**GE Hitachi Nuclear Energy**

Subject: **Response to Portion of NRC Request for Additional Information Letter No. 308 Related to the ESBWR Design Certification – Containment Systems – RAI Number 6.2-148 S01**

**RAI Number 6.2-148 S01**

**DCD Tier 1 and Tier 2 Markups**

Figure 1

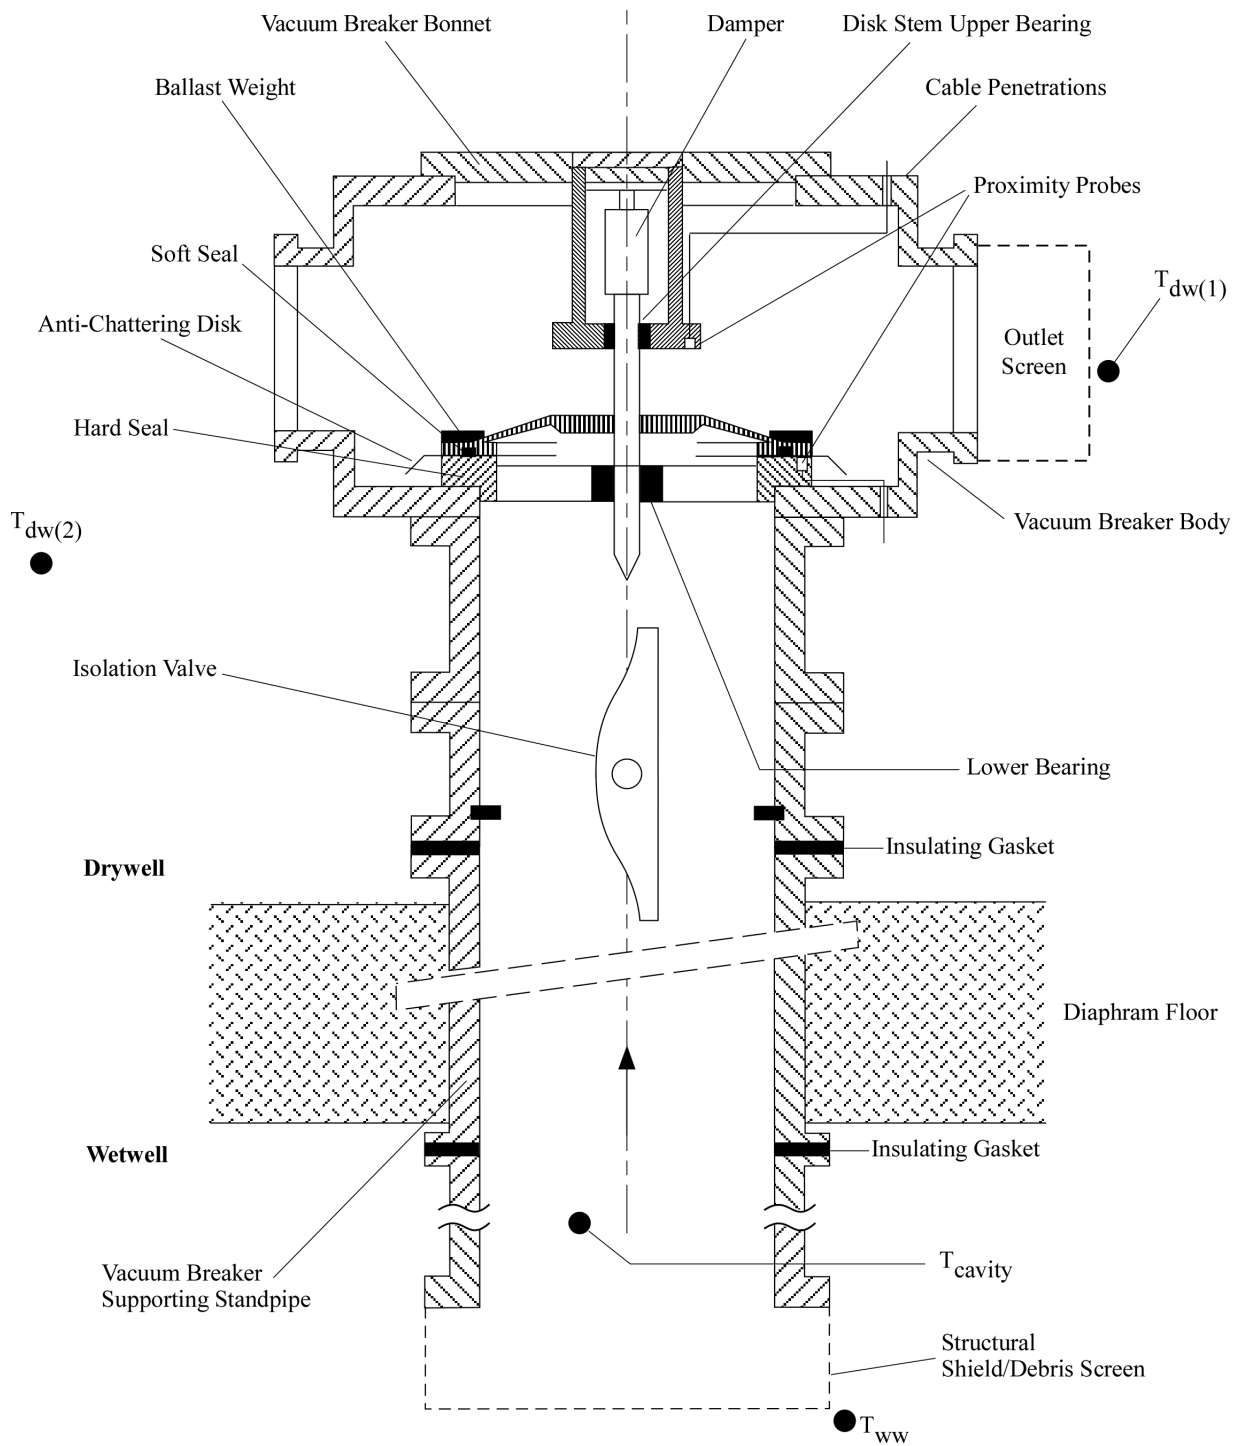
- A. Provide the limit of bypass leakage that activates the sensors to close the vacuum breaker isolation valve.*
- B. State how the temperature differential is calculated.*
- C. Provide the value of temperature differential that activates the sensors.*
- D. Justify that the accuracy of temperature measurement is sufficient to detect the intended temperature differential.*
- E. Provide the calculation that justifies that the temperature differential setpoint is low enough to limit the vacuum breaker bypass leakage to the intended limit.*
- F. "The safety-related logic and control of the isolation valve is independent of the safety related Q-DCIS" is an incorrect statement because the safety-related logic and control of the isolation valve is a subset of the safety-related Q-DCIS, and it is inconsistent with other Tier 1 and Tier 2 sections. GEH should correct this statement in the DCD*

- B. The temperature differential will be calculated using the cavity temperature and the WW temperature; see Figure 1 for approximate temperature sensor locations. The WW temperature is subtracted from the cavity temperature and compared to the drywell (DW) minus WW temperature difference. When the cavity-WW difference exceeds a fraction of the DW-WW difference the VBIV will be signaled to close.

- E. A simple 1-D vacuum breaker component is modeled in TRACG, based on the geometry shown in Figure 1, to calculate the temperatures at different leak rates. It should be noted that a VB extension section in the WW gas space allows the sensors in the extension section to accurately capture the temperature rise due to the DW-WW leakage through the VB.

The leakage area is modeled as an orifice flow area at the top of the VB cavity. The DW and WW thermodynamic conditions (pressures and temperatures) after the first cycle of VB actuation are obtained from the main steam line break LOCA and are used as the VB exterior boundary conditions. The radial heat conduction through the VB pipe wall from the WW is also modeled. The natural convection heat transfer is considered outside of the VB pipe wall. No insulation is applied on the VB pipe. Two cases are analyzed; one for a leakage area of  $0.3 \text{ cm}^2 (A/\sqrt{K})$ , which represents the Technical Specification SR 3.6.1.1.3, above which the VBIV must be closed; the other for a leakage area of  $0.6 \text{ cm}^2 (A/\sqrt{K})$ , which represents the upper analytical limit of the VB bypass leakage. The calculation results are summarized in Table 1. Location 1 and location 2 analyzed are located in the middle of the extension section and close to the exit of the extension, respectively (See Figure 1,  $T_{\text{cavity}}$ ).

Figure 6.2-28. Wetwell-to-Drywell Vacuum Breaker

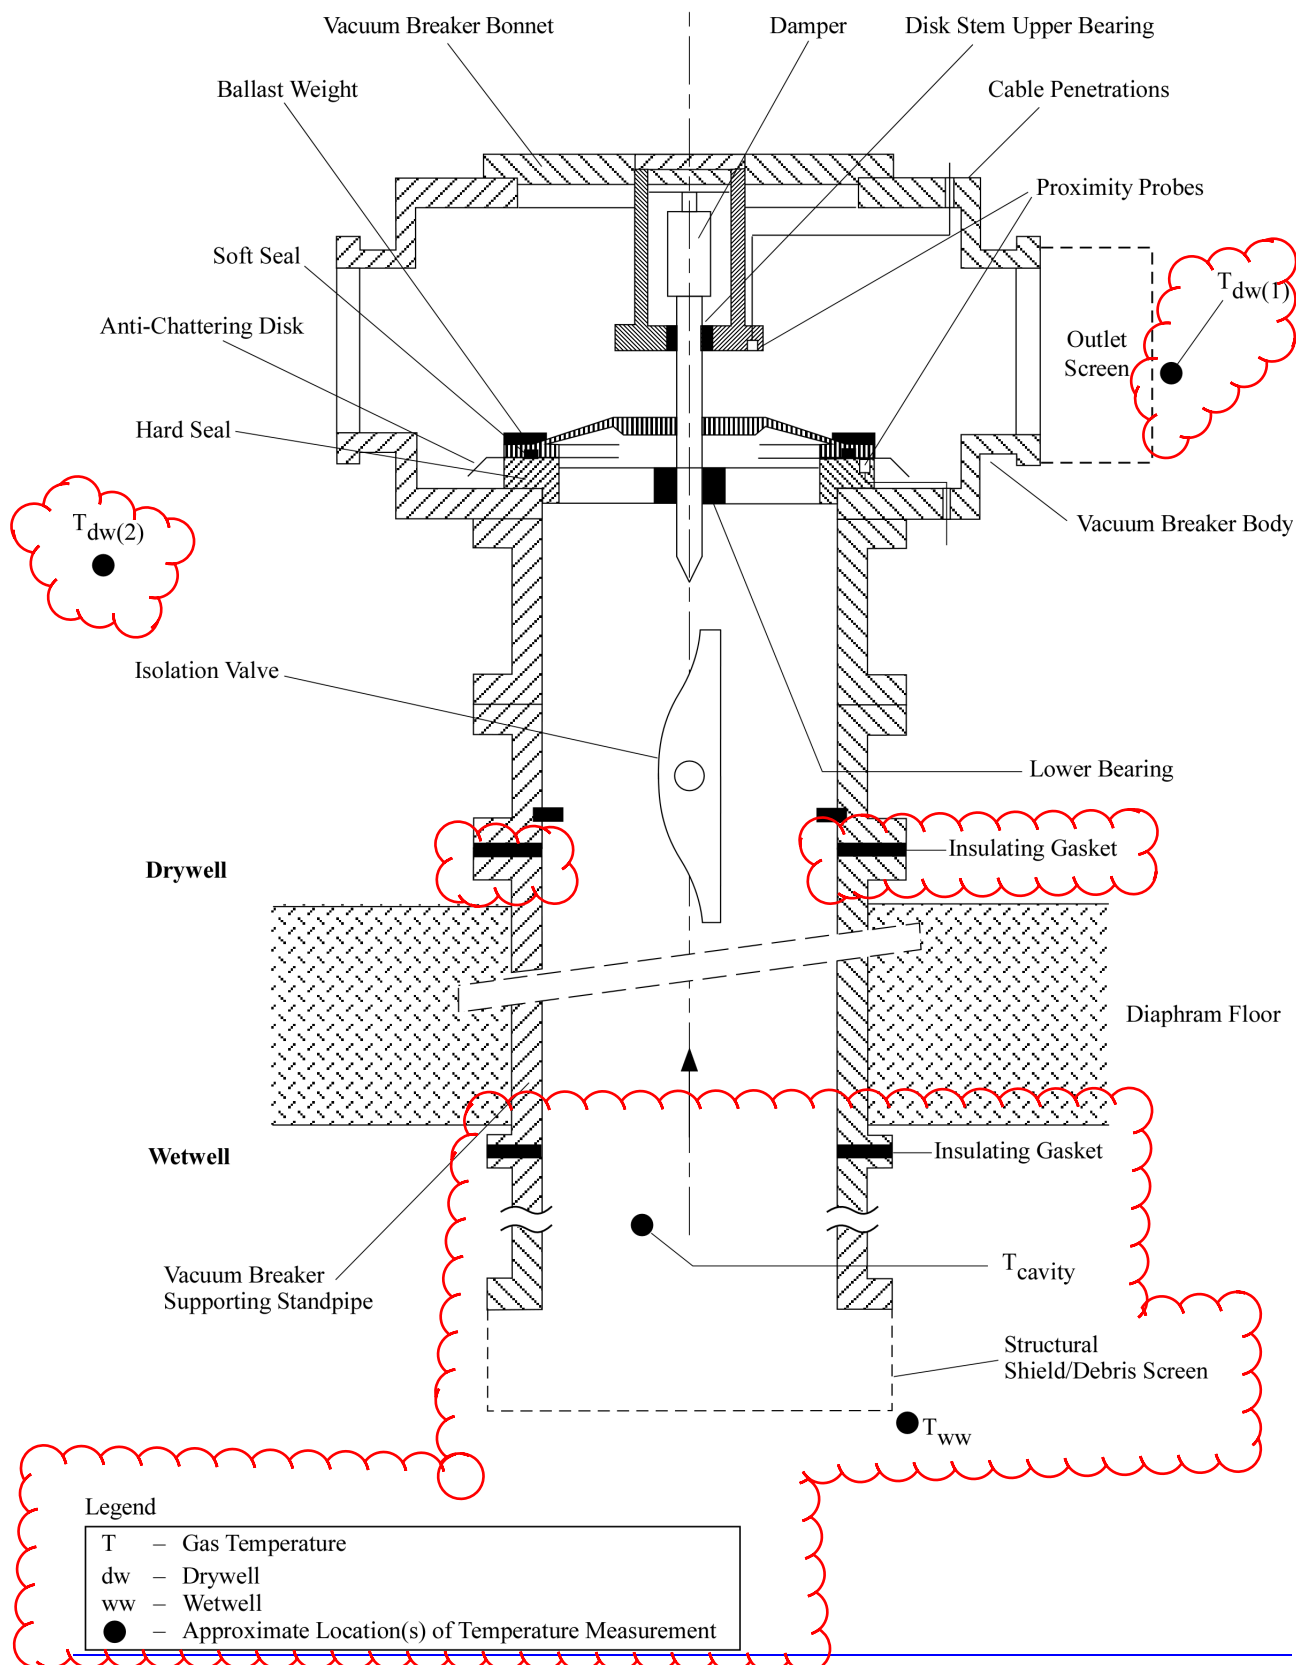
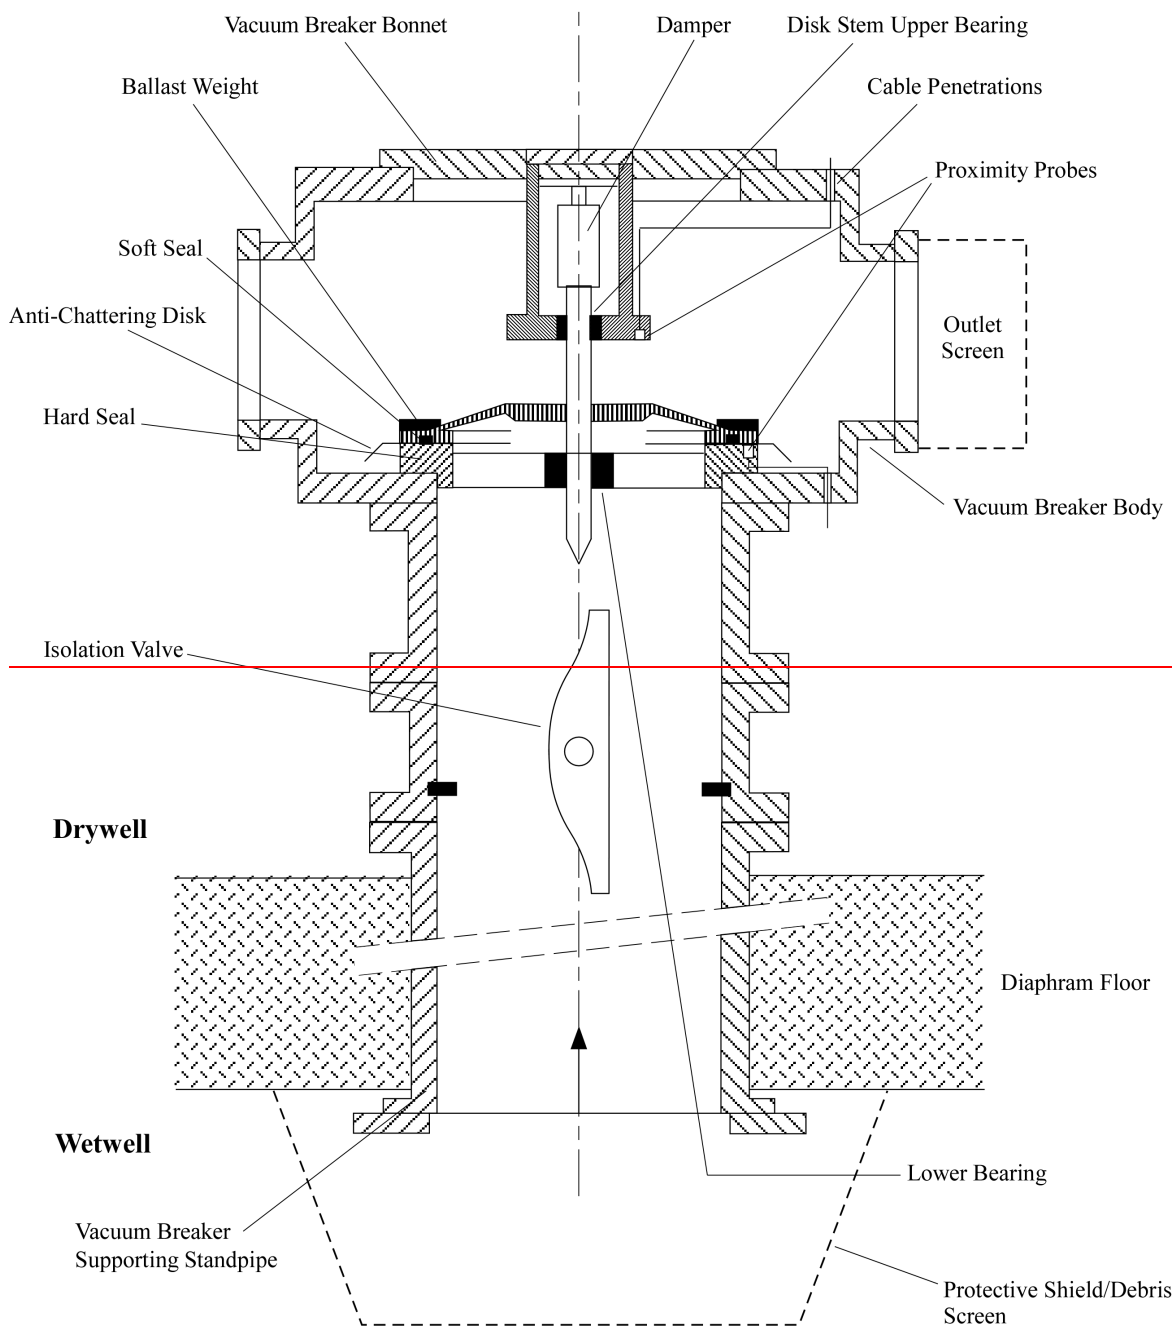
*In response to RAI 6.2-148, GEH proposed changes to ESBWR DCD Tier 2 Section 6.2.1.1.2, which states that "there are temperature sensors located between the vacuum breaker and the isolation valve. These sensors will detect a rise in temperature due to the hot drywell gas bypass, relative to the wetwell gas, which will generate another control signal to close the isolation valve. The safety-related logic and control of the isolation valve is independent of the safety related Q-DCIS. The isolation valve can also be manually opened or closed. For more discussion on the logic control of the vacuum breaker isolation valves, see Subsection 7.3.6." Section 7.3.6 states that actuation logic for the vacuum breaker isolation valve: "The primary closure demand for the VB isolation valve is based upon a temperature differential between the drywell and wetwell and ..." The DCD does not state how the temperature differential is determined, what value of temperature differential is set to activate the sensors, or what is the corresponding limit of bypass leakage.*

Based on additional analysis of the location of the temperature sensors described in DCD Tier 2, Revision 5, Subsection 6.2.1.1.2, the location of the temperature sensors has been moved to the upstream side of the vacuum breaker isolation valve (VBIV) on the wetwell (WW) side of the vacuum breaker penetration. See Figure 1 T<sub>cavity</sub> location. The relocation provides sufficient margin to detect a leaking vacuum breaker without spuriously actuating a VBIV. The description of the temperature sensor location will be revised in Subsection 6.2.1.1.2 of the DCD.

In addition to the proximity sensors, there are temperature sensors located on and in between the vacuum breaker/vacuum breaker isolation valve assembly~~and the~~. See Figure 6.2-28 for approximate temperature sensor locations and sensor terminology~~isolation valve~~. These sensors will detect a rise in temperature between the vacuum breaker and the end of the penetration on the wetwell side due to the hot DW gas leaking past a not fully closed vacuum breaker~~bypass, relative to the WW gas~~. When the difference between the cavity temperature,  $T_{cavity}$ , and the wetwell temperature,  $T_{ww}$ , exceeds a fraction of the difference between the drywell temperature,  $T_{dw1}$ , and wetwell temperature,  $T_{ww}$ , a signal is sent to the vacuum breaker isolation valve to close~~which generates another control signal to close the isolation valve~~. The bulk drywell temperature,  $T_{dw2}$ , (Figure 6.2-28) is measured separately from the vacuum breaker/vacuum breaker isolation valve assembly and is used to detect LOCA conditions and acts as a permissive to allow the vacuum breaker isolation valve logic to function~~. The safety-related logic and control of the isolation valve is independent of the safety-related Safety-Related Distributed Control and Information System (Q-DCIS).~~

**Figure 2.15.1-1. Containment System**

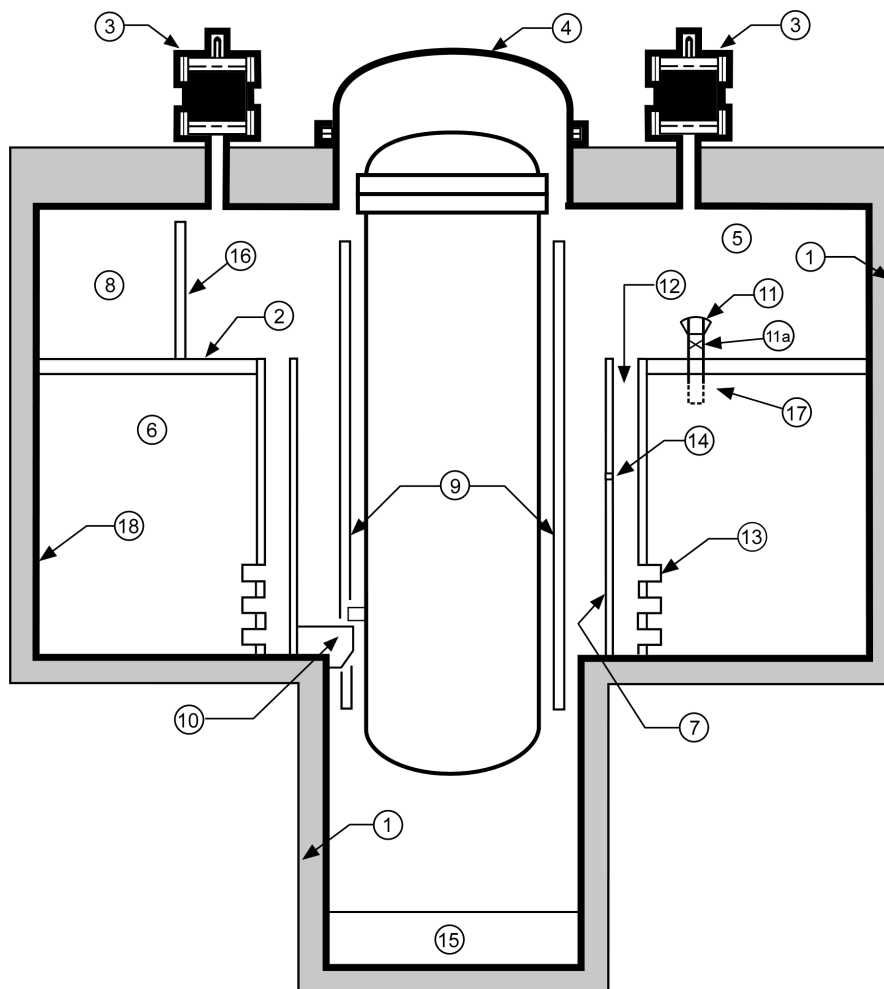
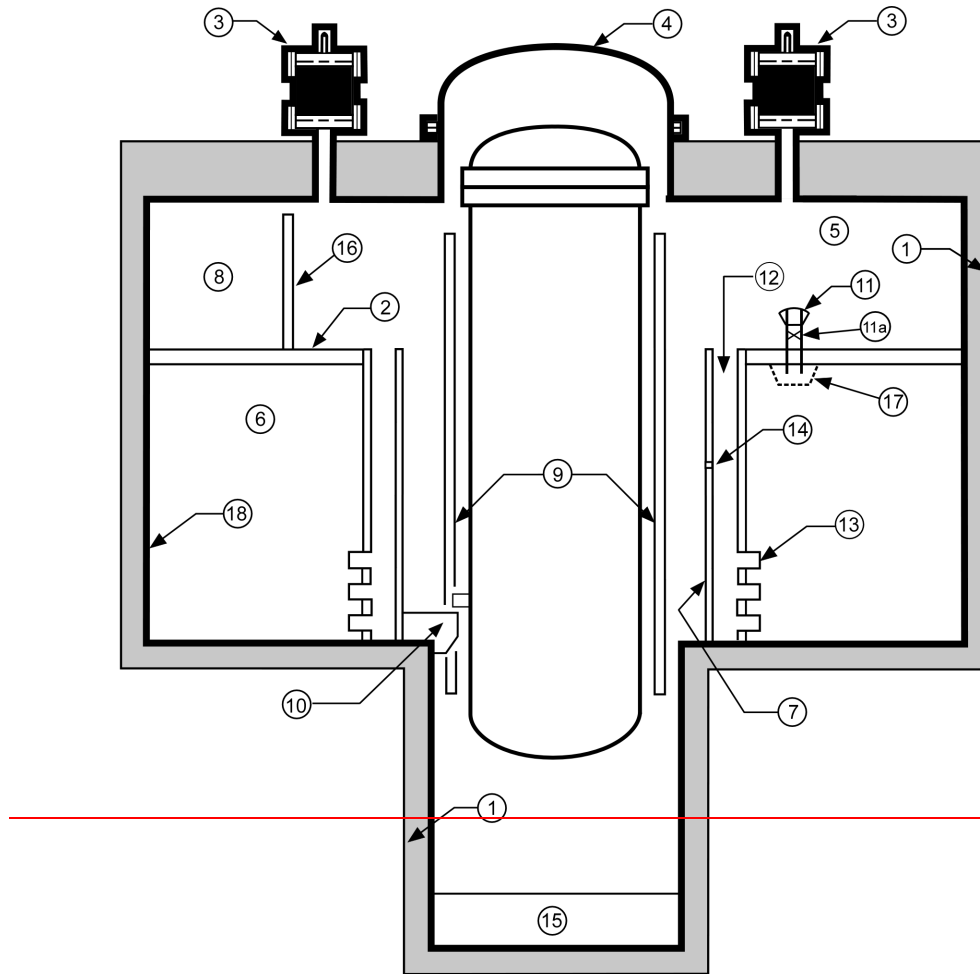
In order to assure pool swell during a LOCA does not impact the bottom of the structural shield/debris screen, Tier 1, Figure 2.15.1-1 will be revised to increase the minimum distance from the WW ceiling (bottom of diaphragm floor slab) to the WW floor from 9600 mm to 12150 mm.

1. Reinforced Concrete Containment Vessel (RCCV)
2. Diaphragm Floor Slab, Distance from bottom of slab to the Wetwell Floor > 12150 mm
3. (6) Passive Containment Cooling System (PCCS)
